**Consumers
Power
Company**

February 20, 1975

Re: Docket 50-255
License DPR-20
Palisades Plant

RESPONSES TO USNRC
Request of February 4, 1975
for Additional Information

February 1975

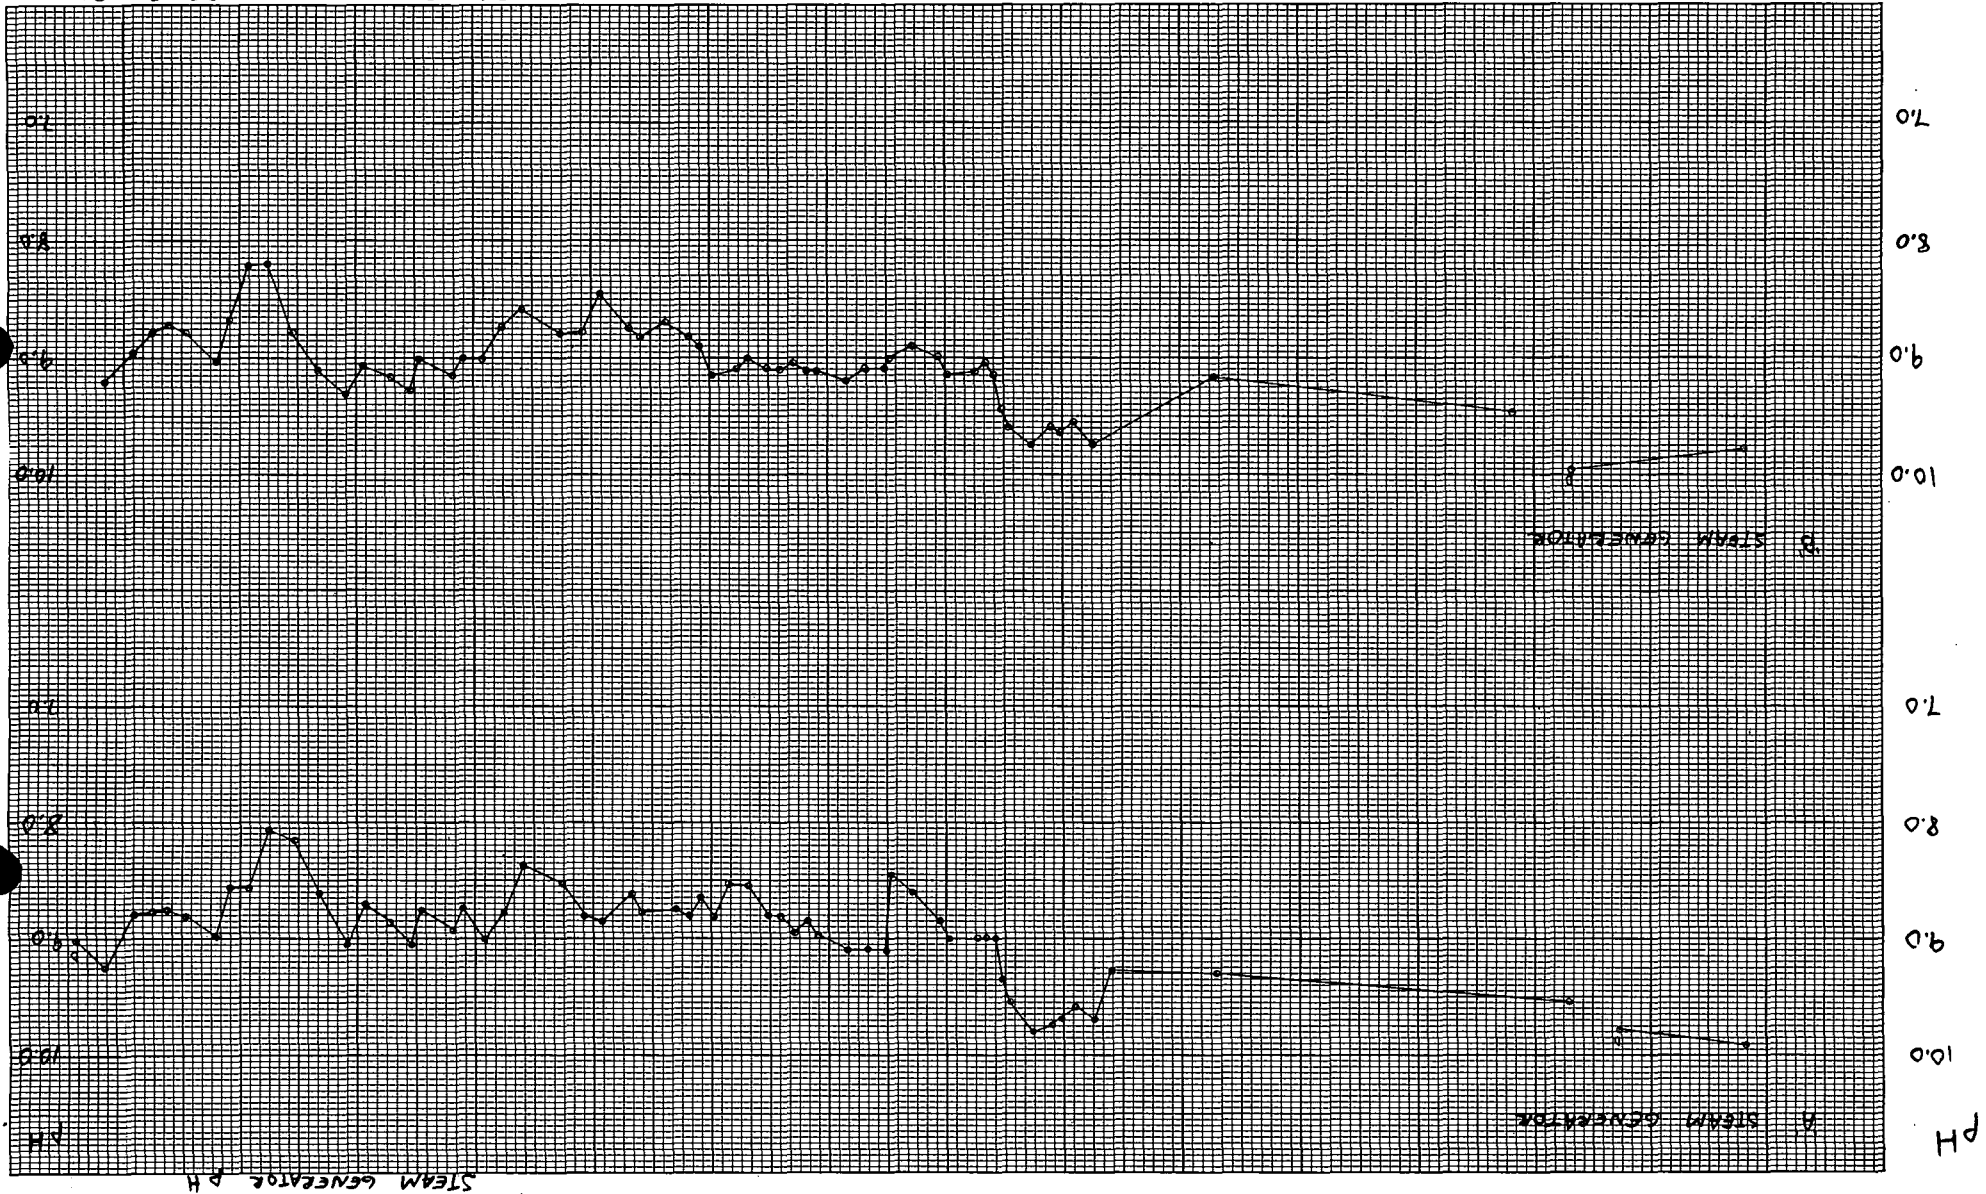
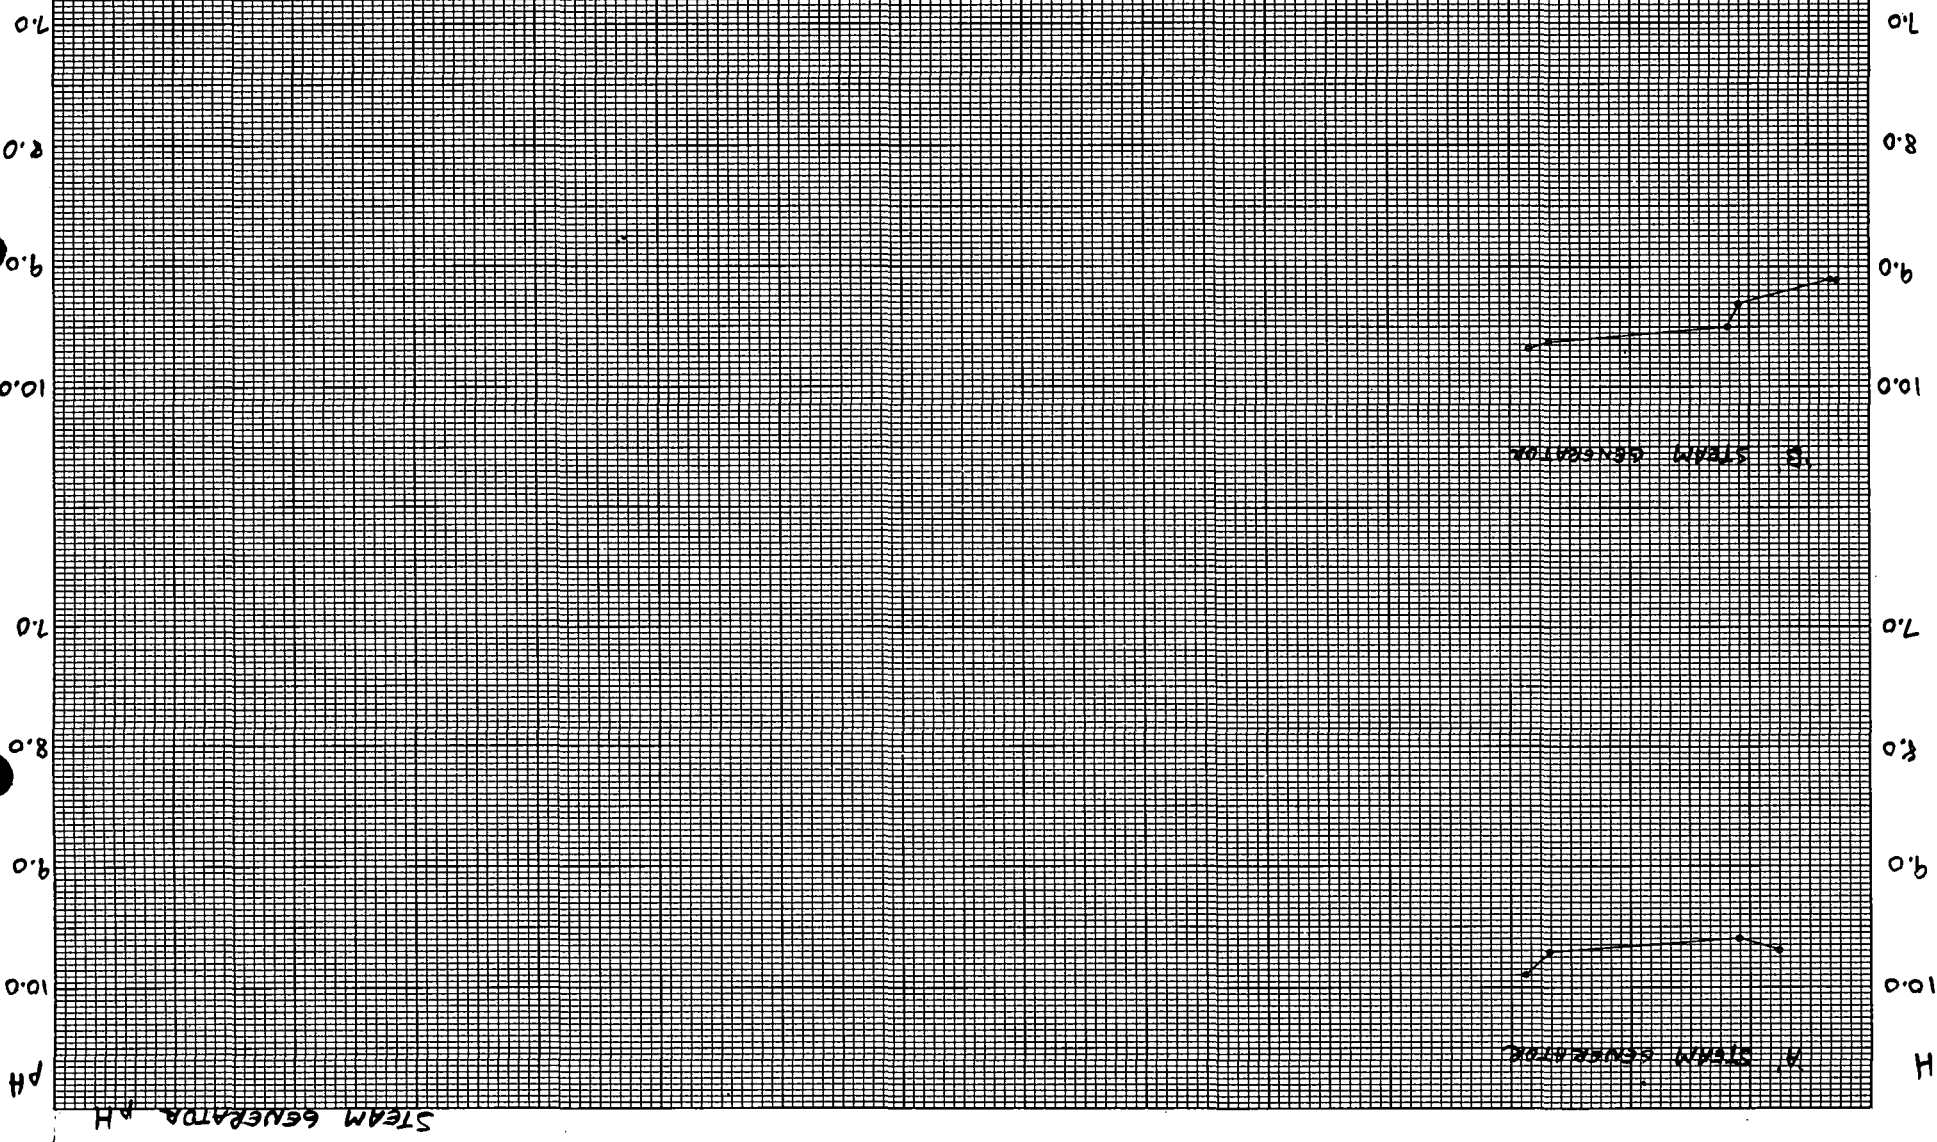
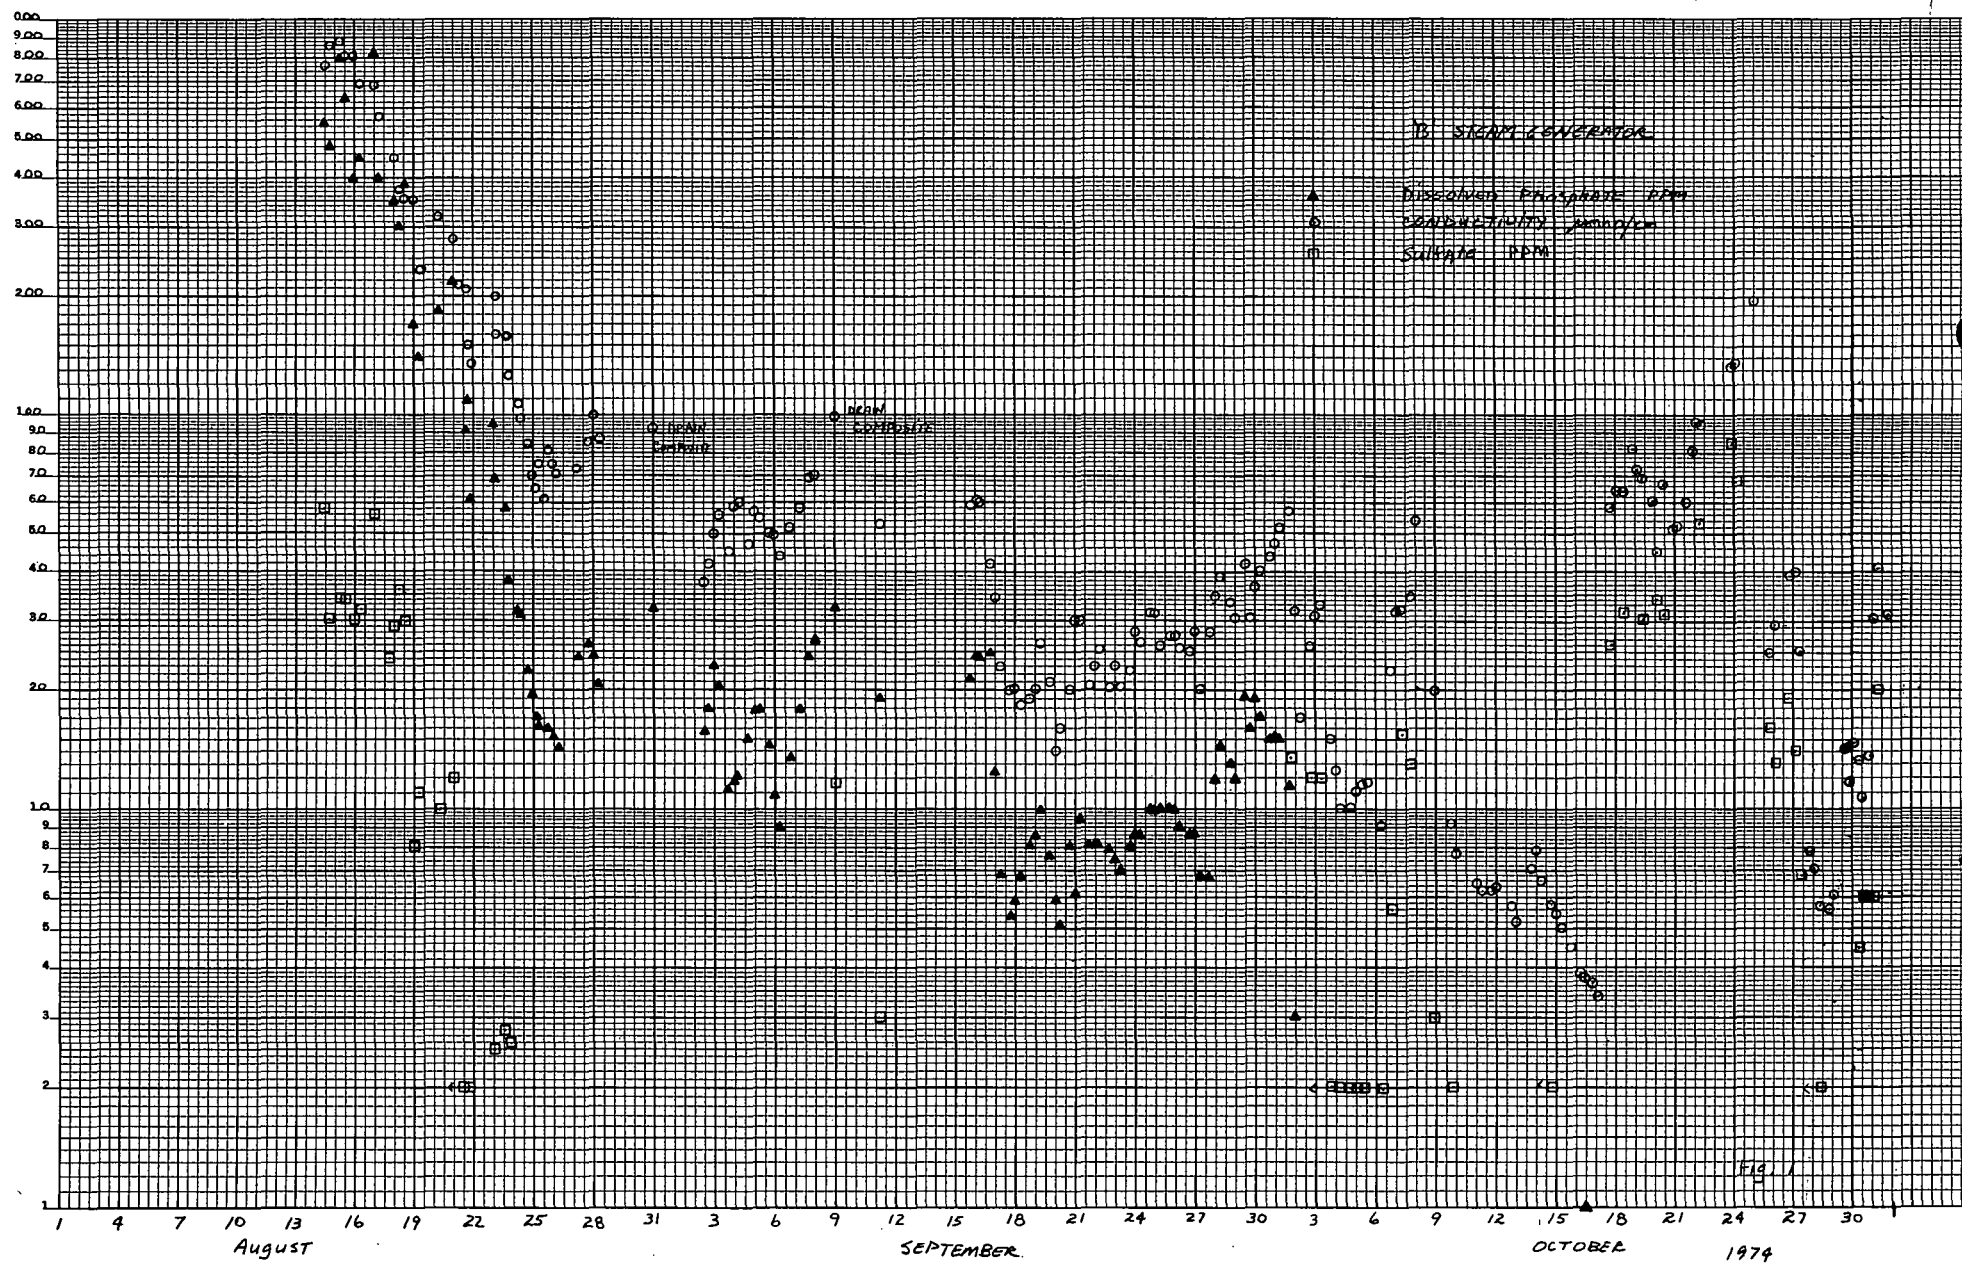
Question 6

"Provide a graph or plot showing the following as a function of time for both steam generators from the onset of isothermal flushing operations to the present:

- a. Phosphate and sulfate concentration,
- b. pH and,
- c. pounds of phosphate and sulfate removed.

The attached graphs, supplemented by the notes listed below, are provided in response to this request.

Notes

1. The letter "D" on several of the graphs indicates a sample (generally a composite) taken during a generator drain.

2. The first accounting of total PO_4 and SO_4 removed from the generators took place in early September; however, due to the error noted late in September with the PO_4 analysis, the total PO_4 removed starts in October. Quite a lot of work would be required to go back and add up the results for the missing four data points (September) and, therefore, it was not done.

3. Due to circulating water leakage (high in SO_4) after October 1, 1974, the pounds of sulfate removed from the generators were no longer calculated. It would be impossible to determine whether we are removing sulfate from the "old sludge" or from the "new sludge" caused by condenser leakage.
